USB 3.0 ENGINEERING CHANGE NOTICE

ECN# 010

Title: DSPORT State Machine

Applied to: USB3.0 (11132008)-final

From Text (and location): figure 10-9

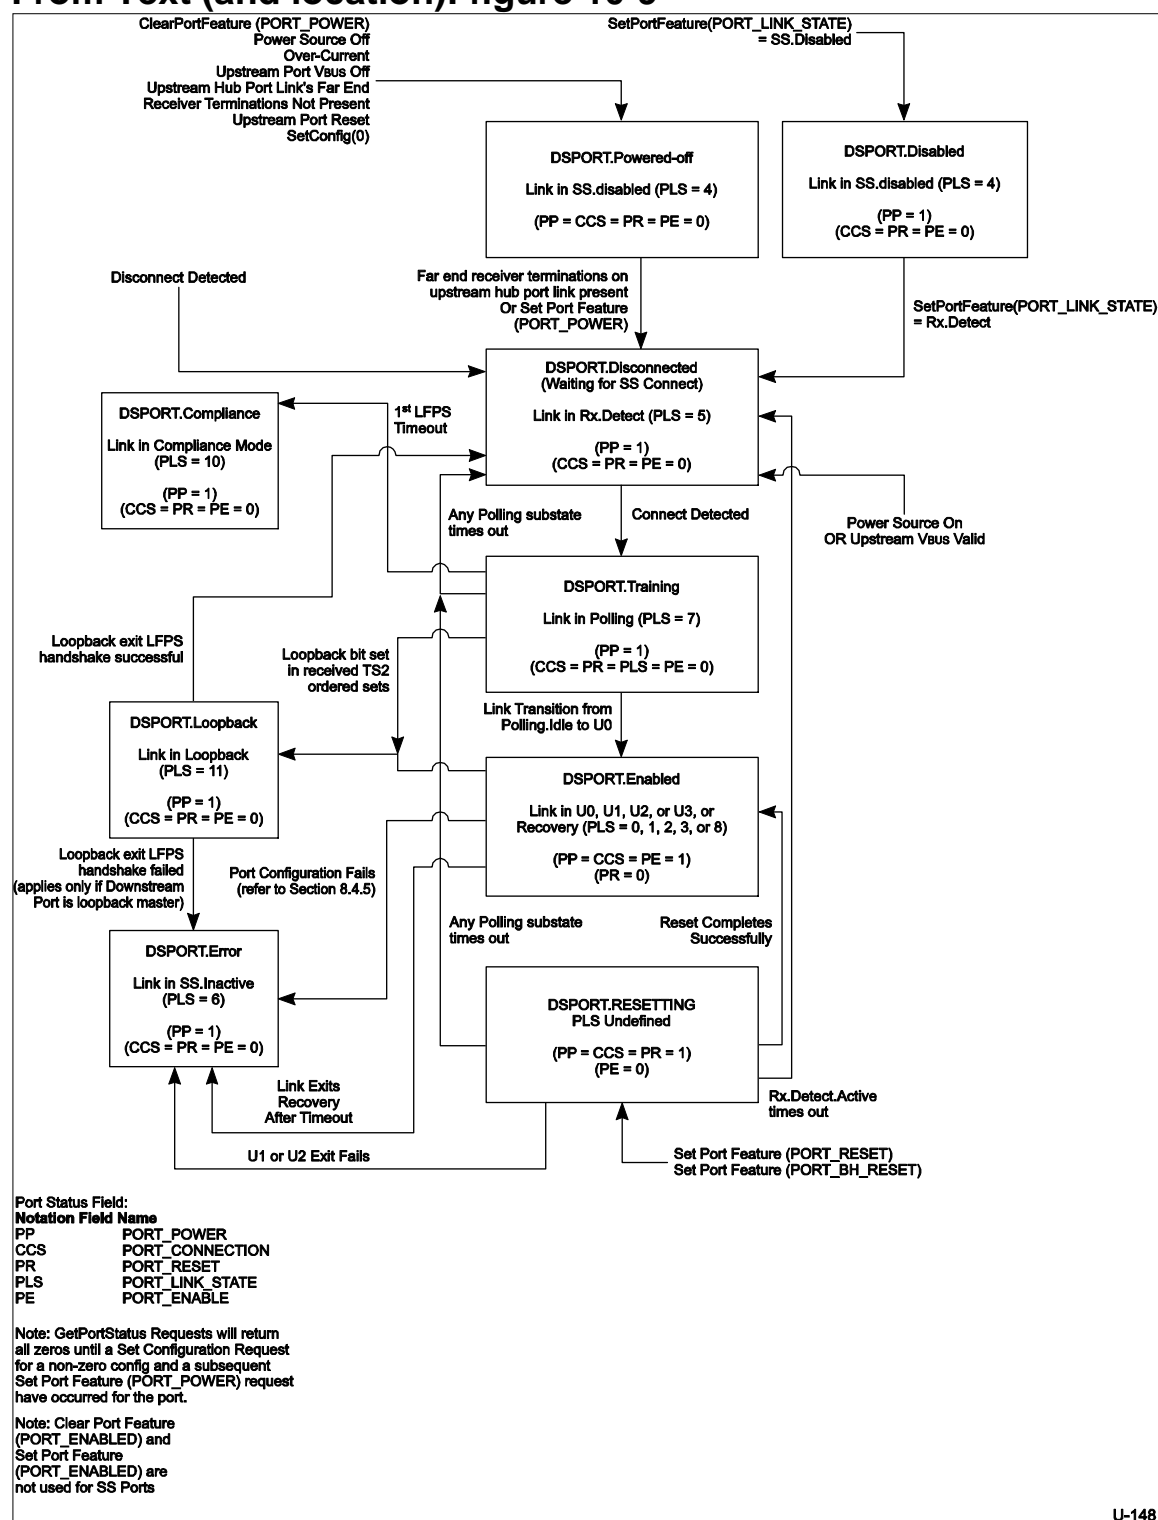
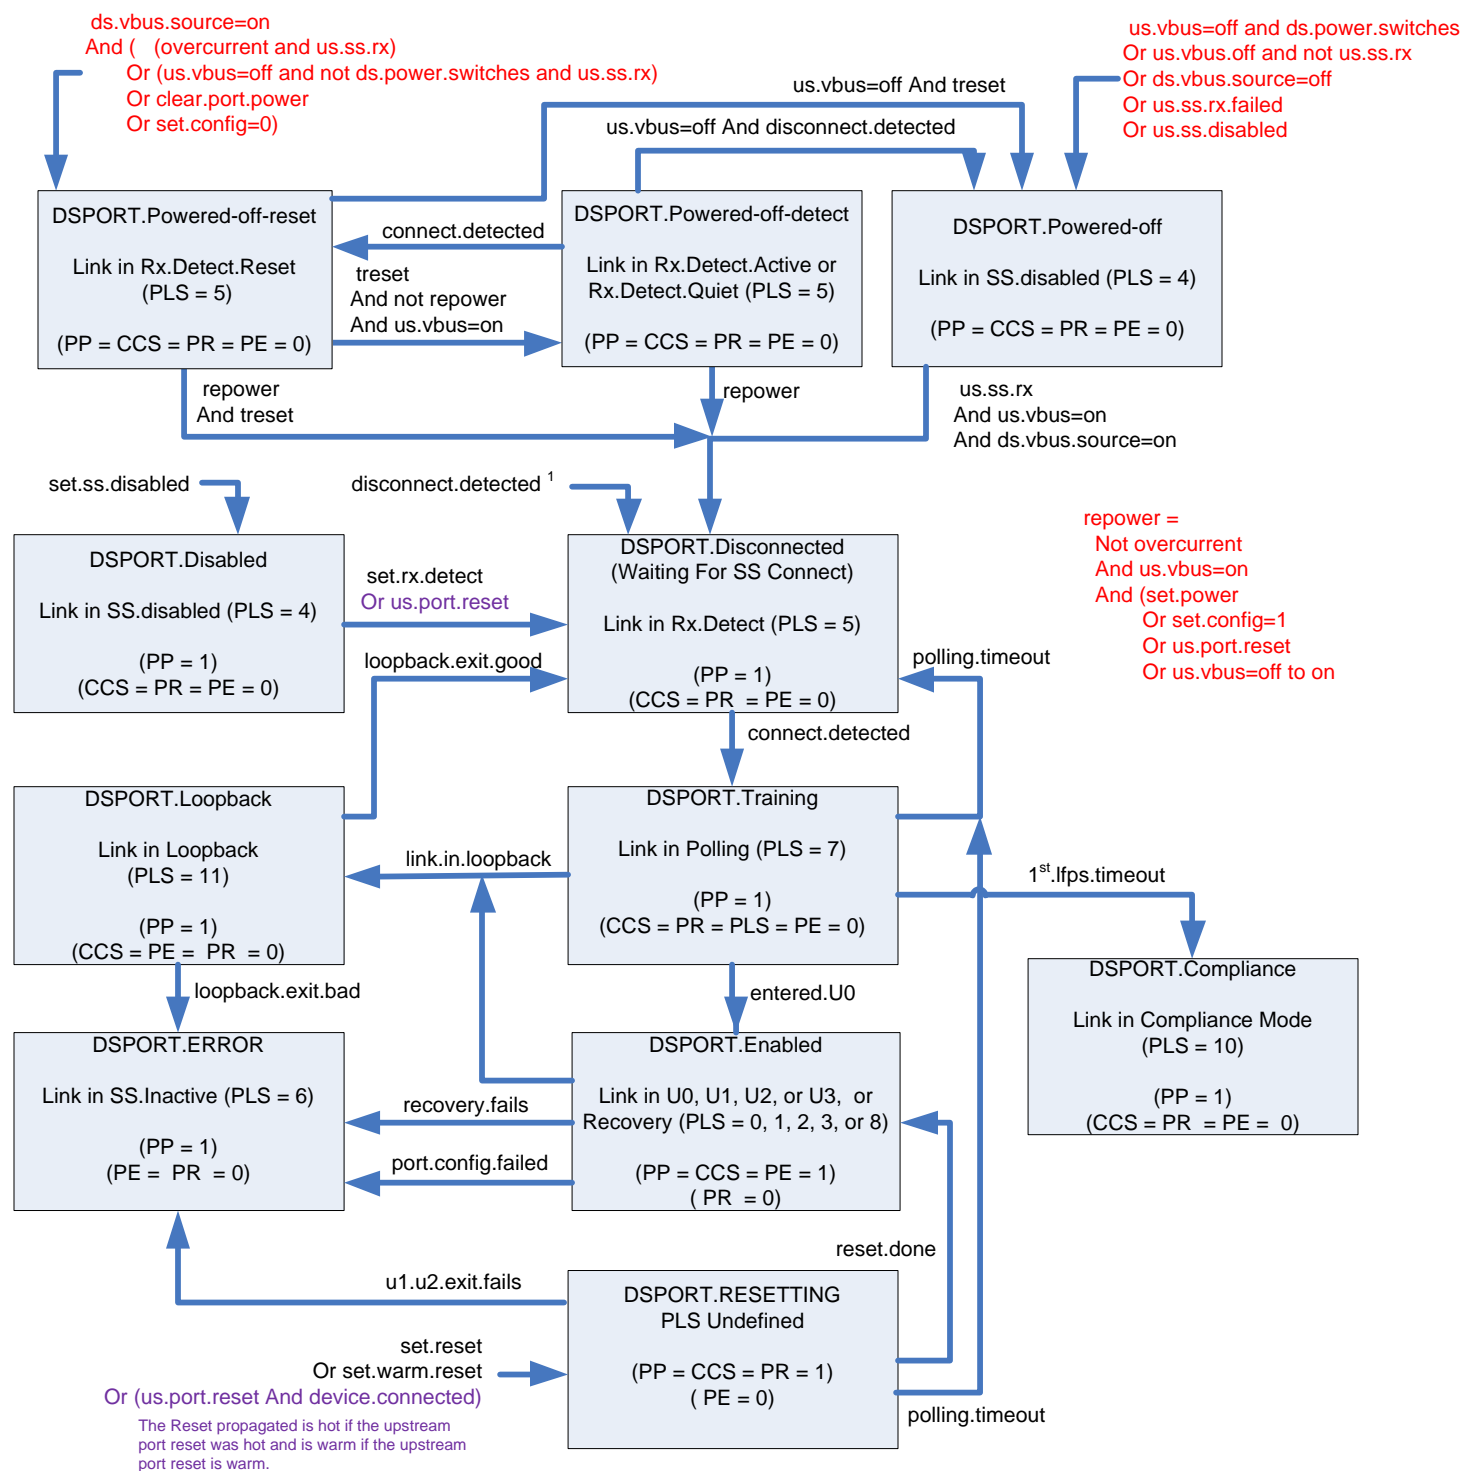
To avoid DS devices from dropping to 2.0 during the "DSPORT.Powered-off" state and possibly requiring the end user to cycle power on the DS device(s) to reconnect them as SS, 2 new states of "DSPORT.Powered-off-reset" and "DSPORT.Powered-off-detect" have been added. For conditions where the DS port is truly powered off and, thus, cannot switch to 2.0 and for the one condition for which it is desired for the DS device to switch to 2.0, the original states (for which the link is in SS.Disabled) are maintained. The DS port power may or may not be off in the new states as well as the original state. Considering the indeterminate status of DS port power, it is desirable to keep the link state simple for guaranteed behavior by the DS device. To that end, the link state is either warm reset or receiver detect.

Actual Change Requested

Table 10-0. Downstream Facing Hub Port State Machine Diagram Legend
